Agenda Planning Commission City Of Edina, Minnesota City Council Chambers

Subject: Comprehensive Plan Amendment, Rezoning and

Comprehensive Plan Amendment, Rezoning and Subdivision – 5120 & 5124 Hankerson

Site Plan with Variances and Subdivision

SITE PLAN

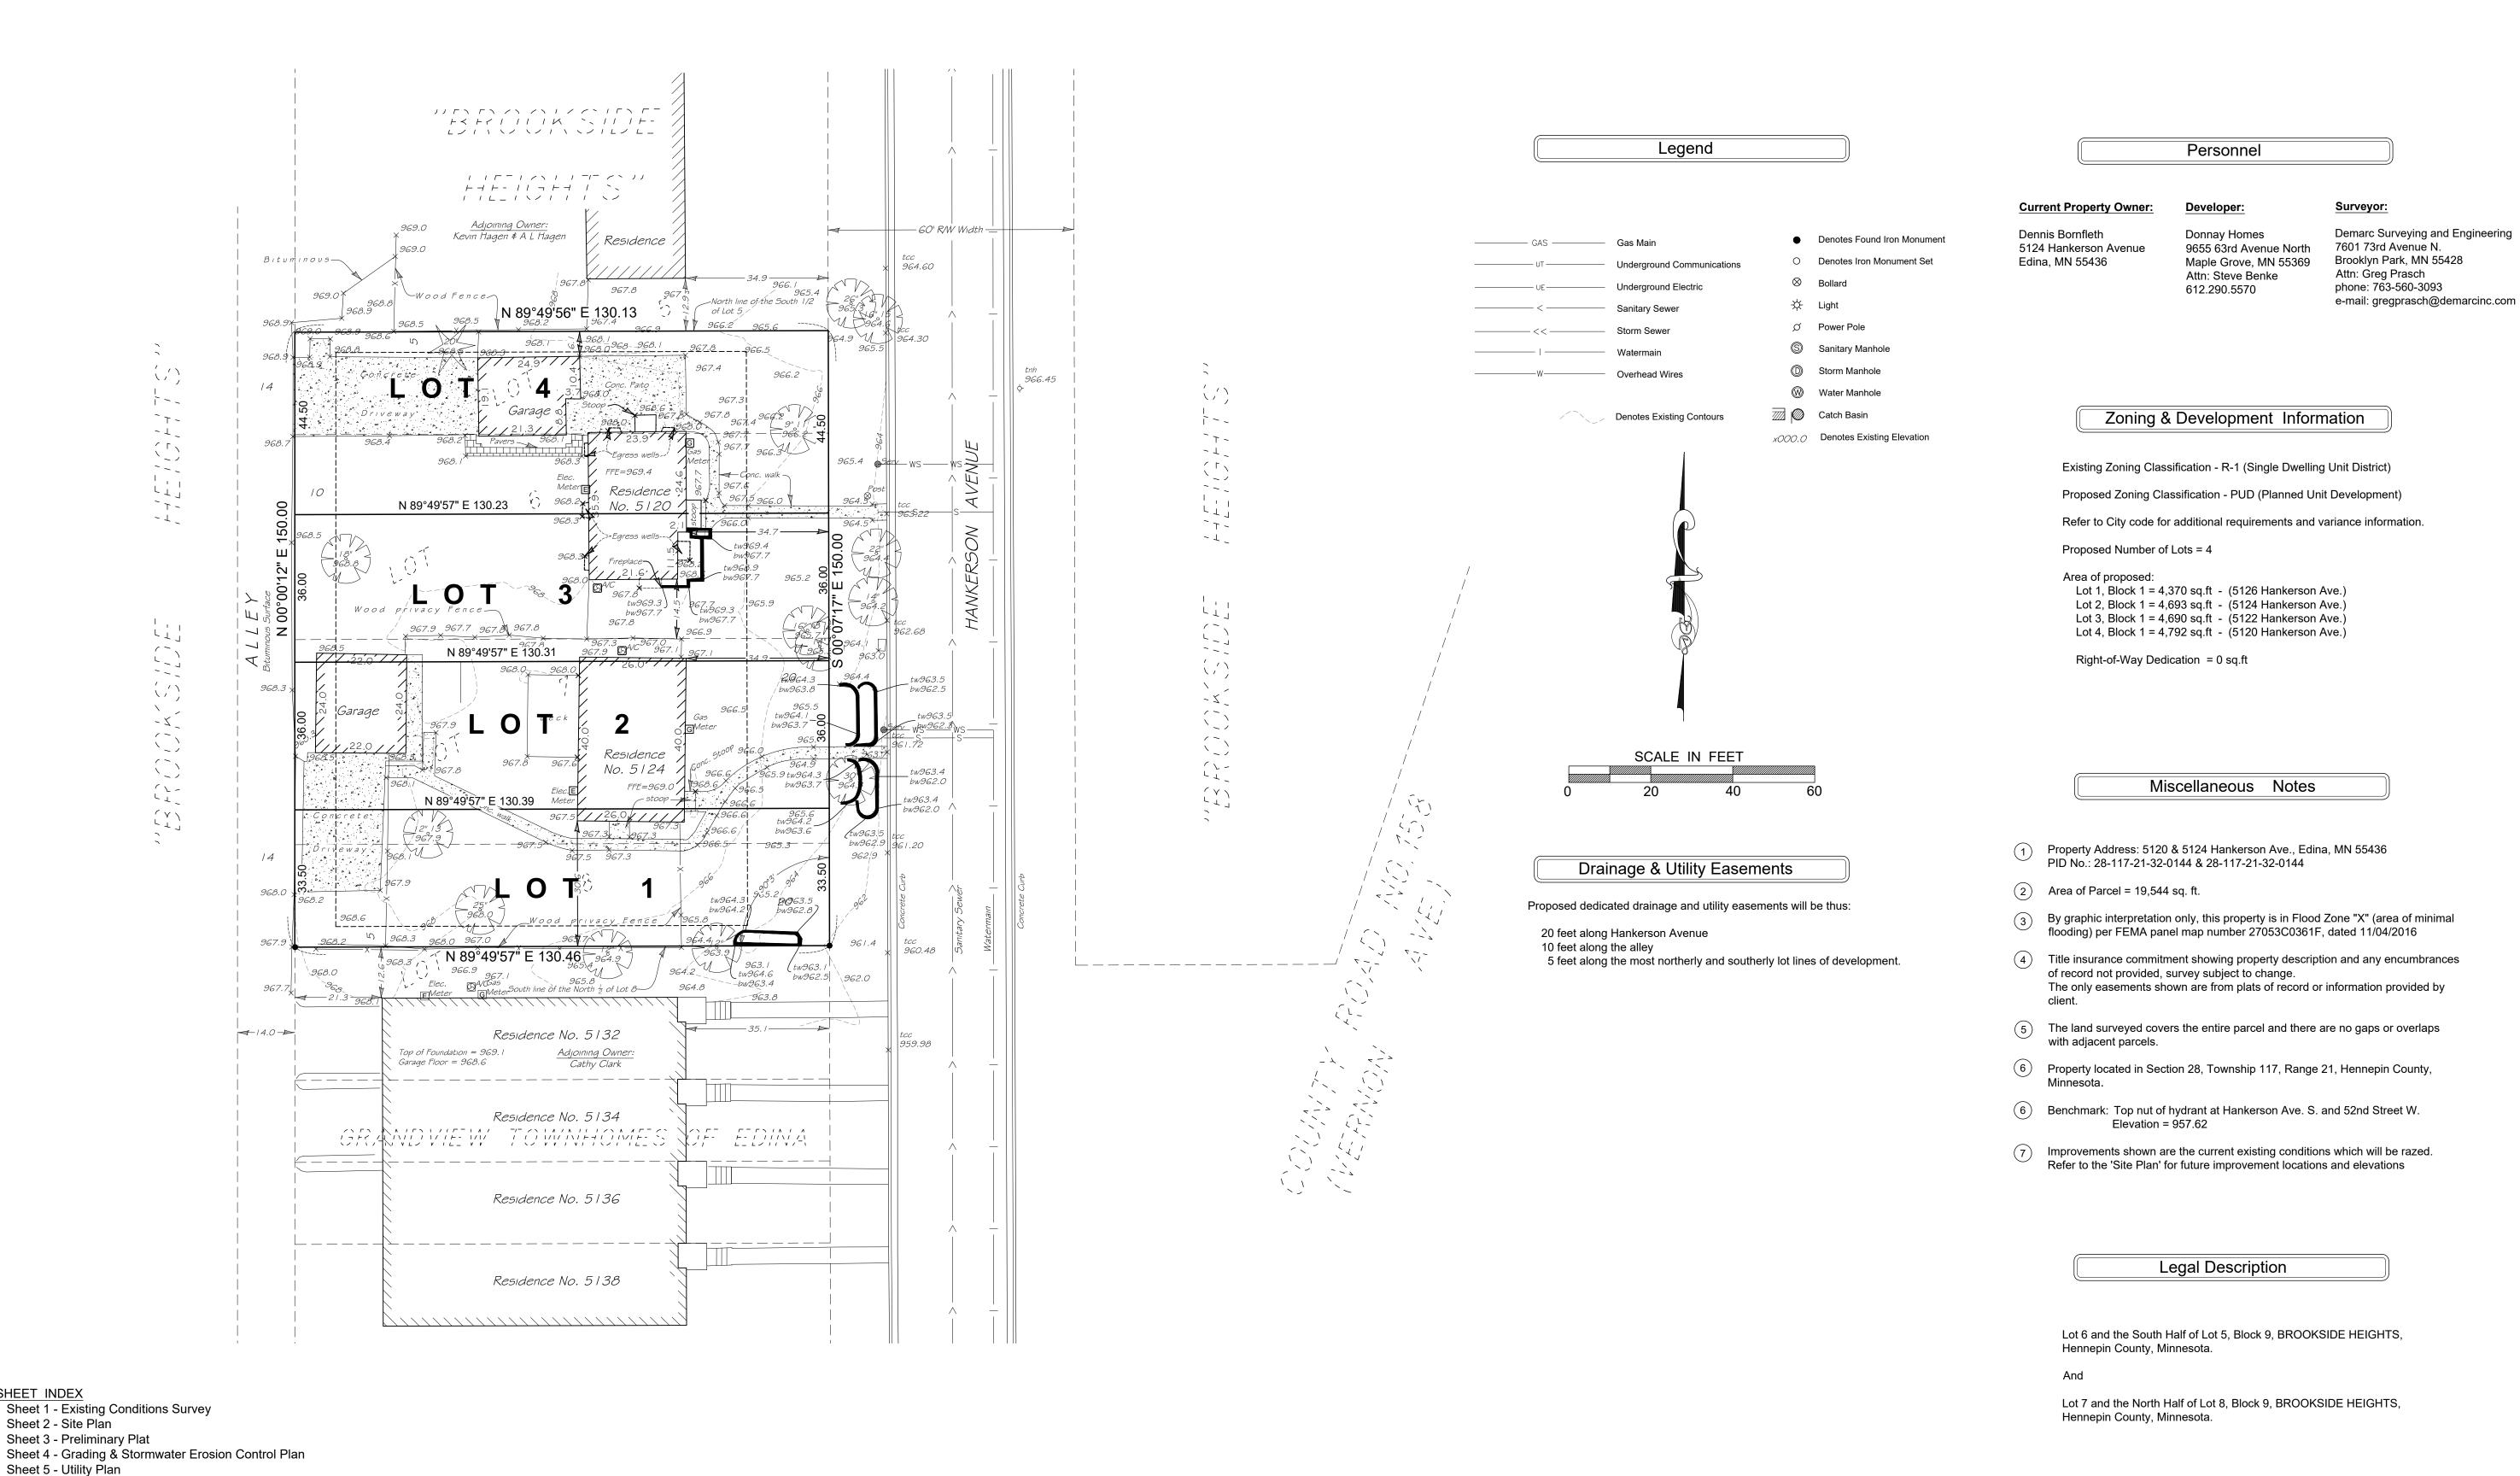
Based on the perimeter of the site 14 over-story trees would be required. The site plan shows 16 existing and proposed over-story trees around the perimeter of the site.

The city engineer has reviewed the proposed plans and found them to be acceptable subject to the comments and conditions outlined in the attached engineering memo. Any approvals of this project would be subject to review and approval of the Nine Mile Creek Watershed Districts, as they are the City's review authority over the grading of the site.

- 1. The Final Development Plans must be consistent with the Preliminary Development Plans dated March 4, 2024.
- 2. The Final Landscape Plan must meet all minimum landscaping requirements per Chapter 36 of the Zoning Ordinance. A performance bond, letter-of-credit, or cash deposit must be submitted for one and one-half times the cost amount for completing the required landscaping, screening, or erosion control measures at the time of any building permit. The property owner is responsible for replacing any required landscaping that dies after the project is built.

- 3. Compliance with all the conditions outlined in the city engineer's memo dated April 2, 2024.
- 4. Submit a copy of the Nine Mile Creek Watershed District permit. The City may require revisions to the approved plans to meet the district's requirements.
